To: Development Permit Panel

File: DP 18-835533

Re: Application by Mosaic No. 3 Road and Williams Limited Partnership for a
Development Permit at 9900 No. 3 Road and 8031 Williams Road

PROJECT 9900 NO.3 ROAD & 8031 WILLIAMS ROAD		PROJECT NUMBER 18-02
DRAWING TITLE SOUTH & WEST ELEVATIONS		DWG. NO. A301
DATE APRIL 2018	SCALE 1/8"=1'-0"	DRAWN AT
	CHECKED HC

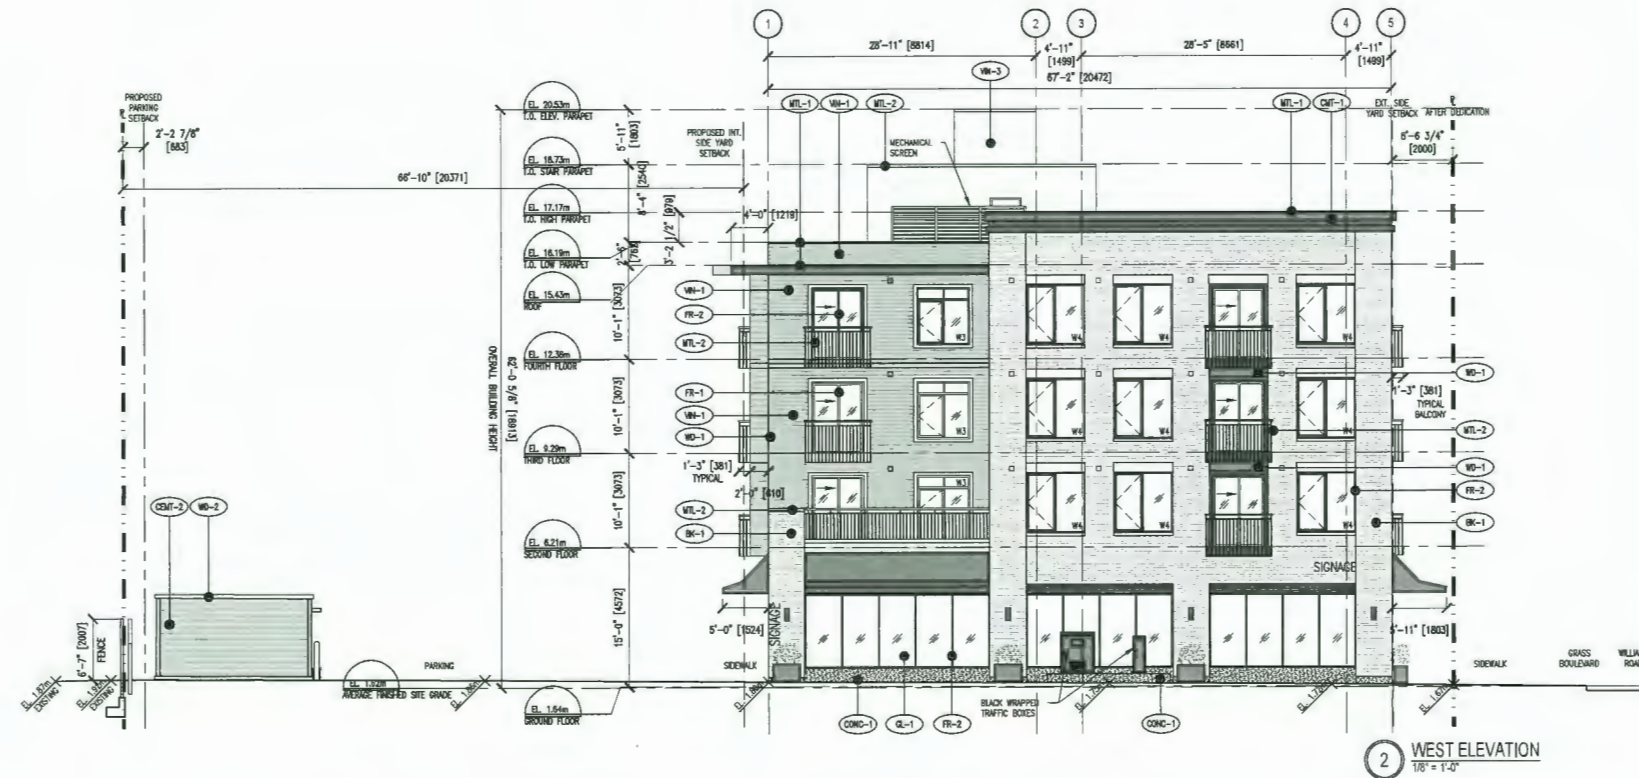
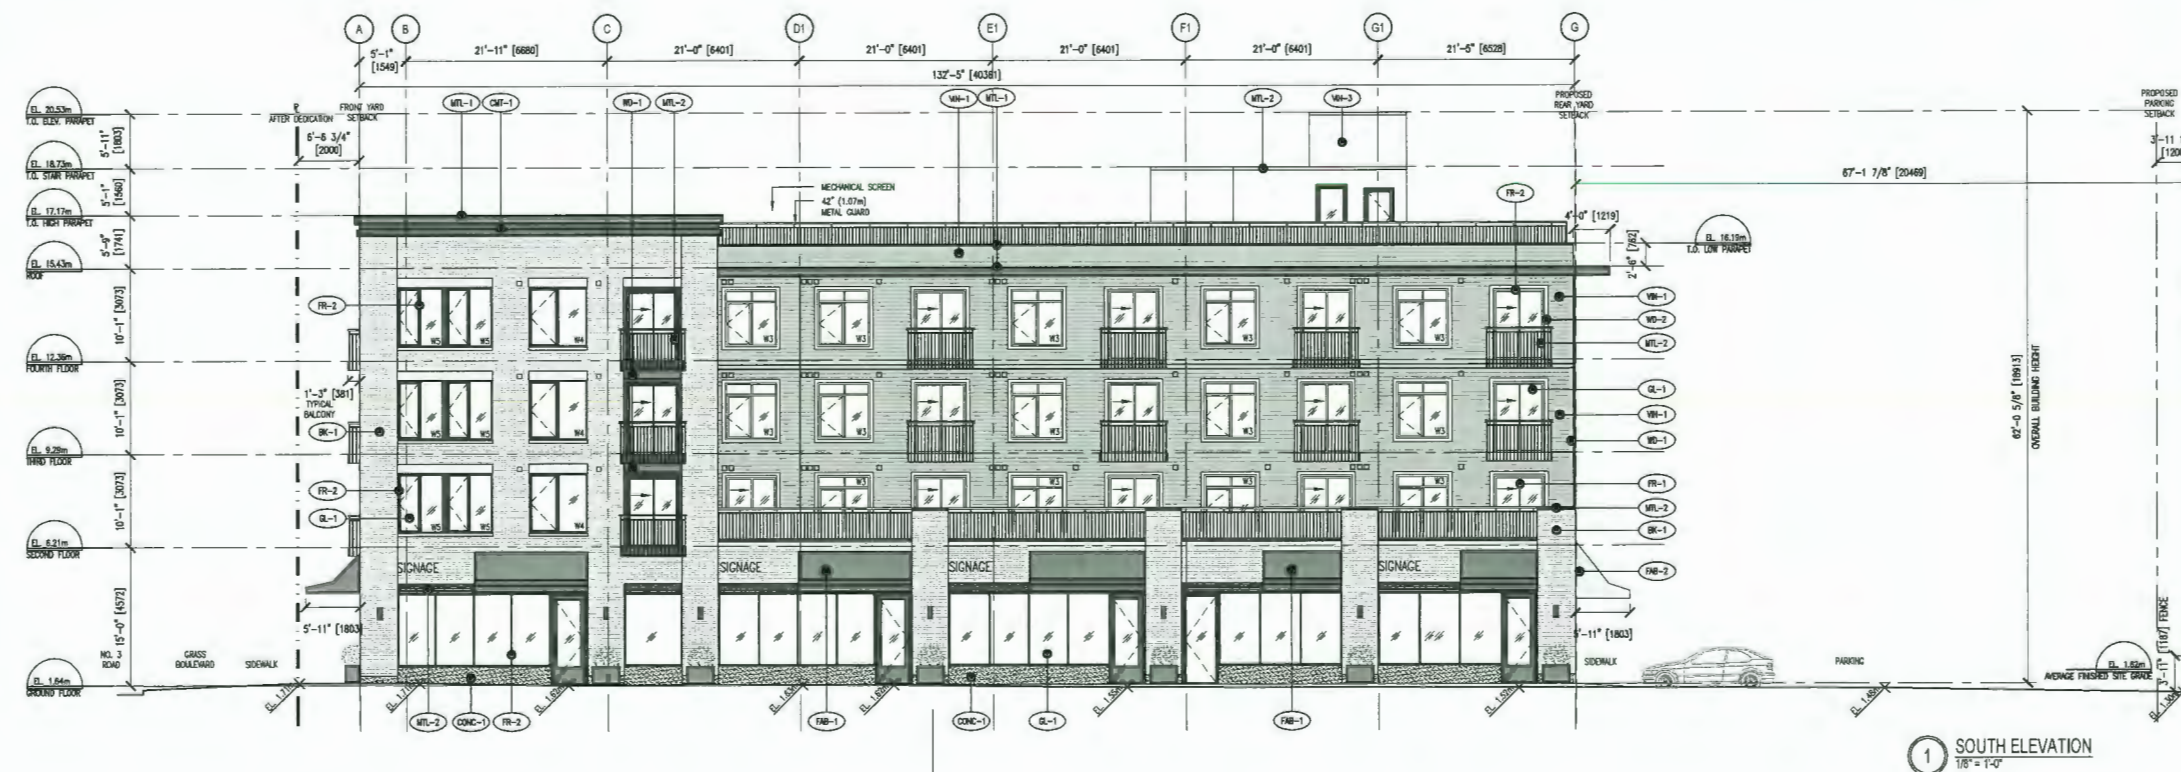
- arrangement of alternate cladding and colour above the ground floor further away from the corner creates a strong beltline and horizontal expression; consider redesigning to add more verticality to building facades away from the corner.

Refer to above commentary regarding siding revisions to remove the 'beltline' on the fourth floor. The brick podium is crucial to the architectural expression of the base of the building, and announcing the commercial presence on the ground floor.

2 BIKE SHELTER FRONT ELEVATION
1/4"=1'-0"

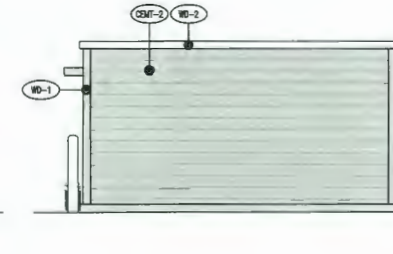
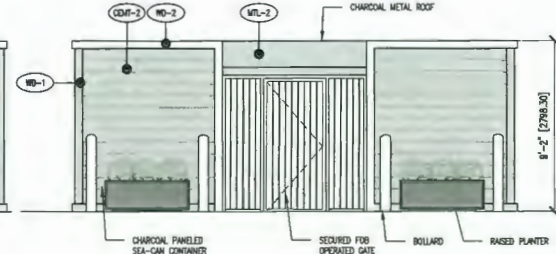
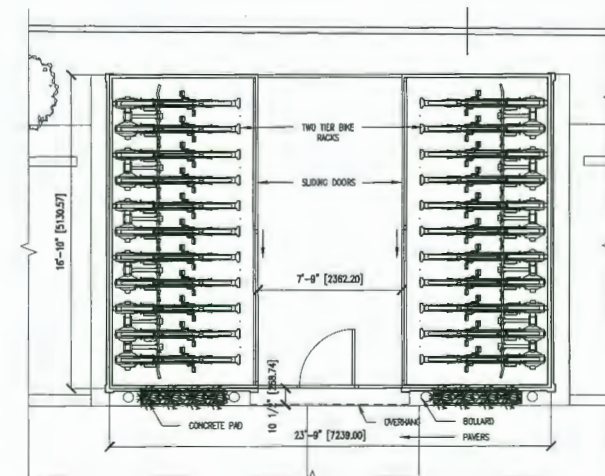
Design improvements to the bike shelter are proposed, including revision to horizontal fibre cement plank siding to complement the more predominant visual language of the horizontal siding on the building, and to ensure long term durability given the shelter's location in the parking area. The trim on the external vertical corners of the shelter are revised to a dark colour to match the

siding, mirroring the language on the corners of the principal building. Further, a black metal overhang is proposed over the access gate to respond to the black overhangs that mark the CRU entries, and planters framing the entry point will match the colour and character of those proposed along the building frontage.
